Subject: Supplement to Notification of Class 1 Permit Modification Construction Updates for the Technical Area 63 Transuranic Waste Facility Container Storage Unit, Los Alamos National Laboratory, Hazardous Waste Facility Permit, EPA ID # NM0890010515

Supplement -
Class 1 Permit Modification
Construction Updates for the
Technical Area 63 Transuranic Waste Facility
Container Storage Unit,
Los Alamos National Laboratory
Hazardous Waste Facility Permit

EPC-DO-16-203

Figure: TA-63 TWF Concrete Pad As-Built Slopes

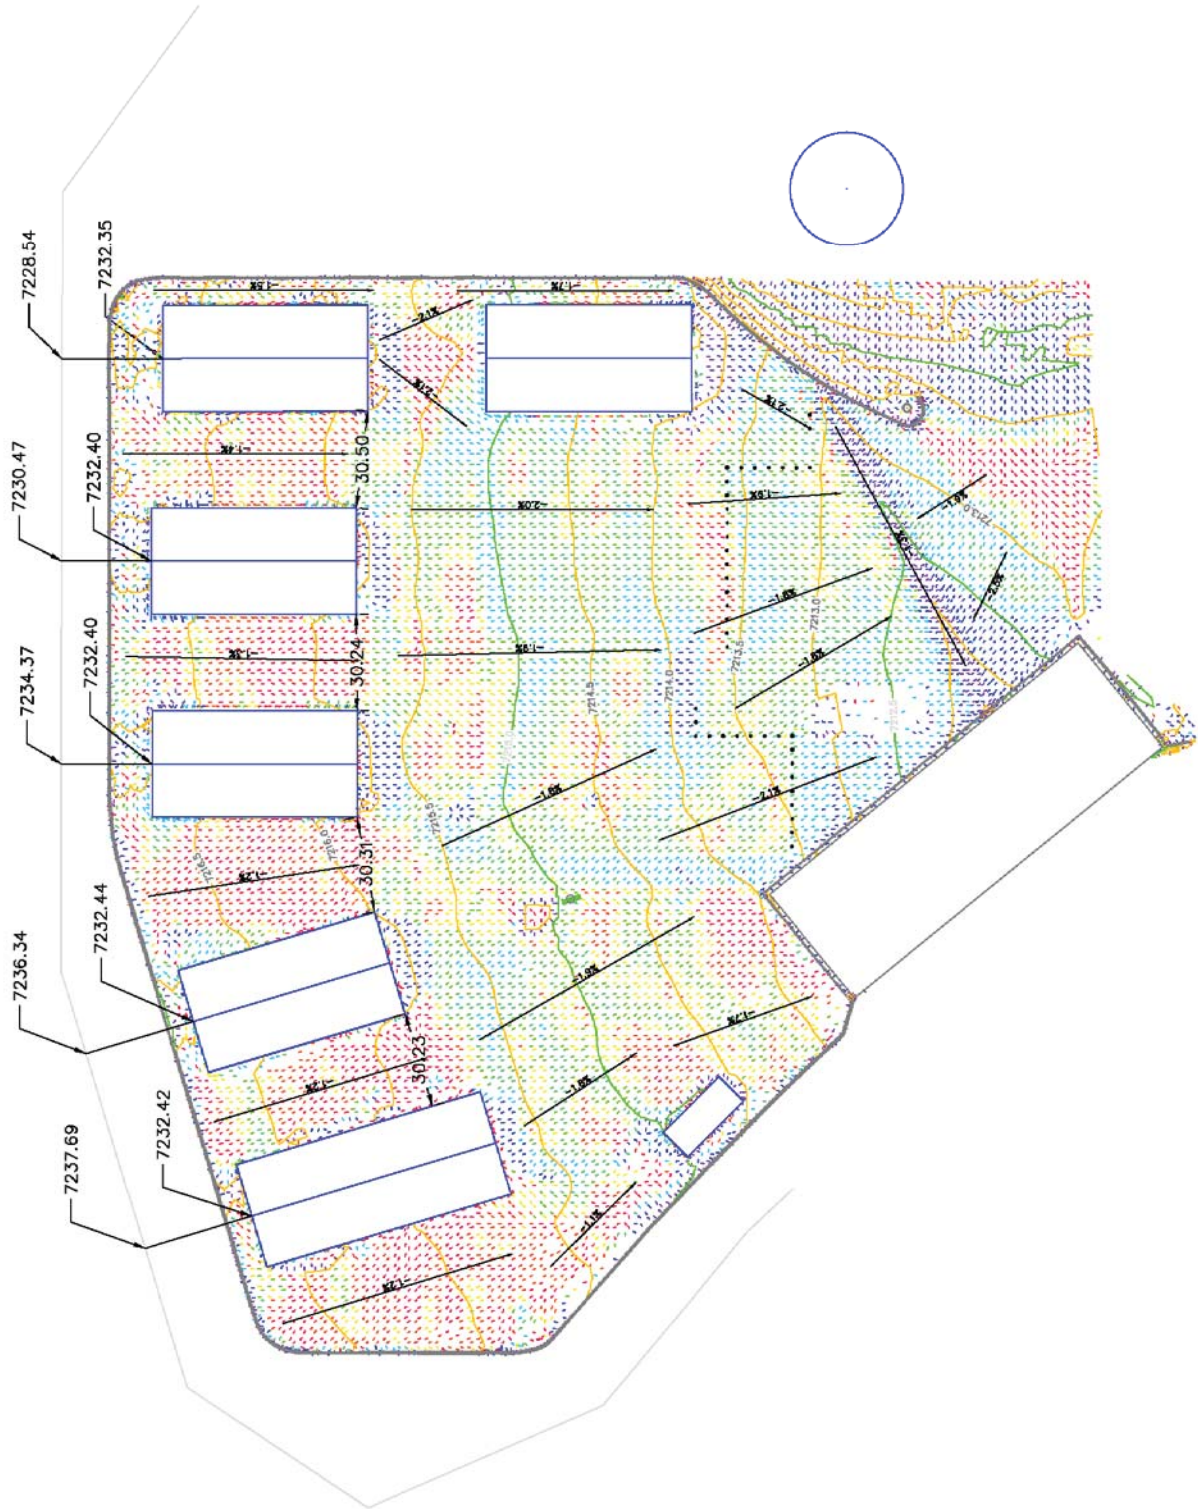
As included in Permit Attachment A, *Technical Area (TA)-Unit Descriptions*, Section A.6.1, *Concrete Pad*, Section A.6.5, *Retention Basin*, and Section A.6.9, *Control of Run-On/Run-off*, the slope of the concrete pad directing run-off to the TA-63 TWF retention basin was described as nominally or approximately 2%. As constructed at the facility, the runoff slope of the concrete pad is not constant due to the need to contour the areas between the boundaries of the pad and the storage buildings while maintaining a sufficient slope to direct runoff to the retention basin. Due to this factor, the range of slopes present at the site expressed in percentages is varied and the 2% criteria given in the text also represents an inaccurate bounding value. As such, the description in the permit is no longer correct. Therefore, the affected sections of the facility description have been revised to replace the description with a range of percentages for the concrete pad slopes. As shown in the figure in Attachment 2 of this submittal, these slopes vary from 1.1% to 2.5%. This range has been added to the permit description. This permit revision

- Section A.6.1, *Concrete Pad*, states that “The pad is sloped at an approximate 2% grade to promote drainage of storm water and potential fire suppression water to the retention pond...” This has been altered to read “The pad is sloped in a range from 1.1% to 2.5% to drain storm water and potential fire suppression water to the retention pond...”

- Section A.6.5 *Retention Basin*, contains a statement that “The retention basin is designed to collect surface storm water or melt water run-off from the concrete pavement via the slope (nominally 2%) of the concrete pad...” This sentence has been revised by deleting the parenthetical phrase “nominally 2%” and replacing it with the phrase “ranging from 1.1% to 2.5%.”

- Section A.6.9 *Control of Run-On/Run-off*, states that “The TWF site slopes nominally at a 2% grade to promote drainage to the retention pond.” This sentence has been replaced with “The concrete pad within the permitted unit at TWF is sloped in a range from 1.1% to 2.5% to drain storm water to the retention pond.”
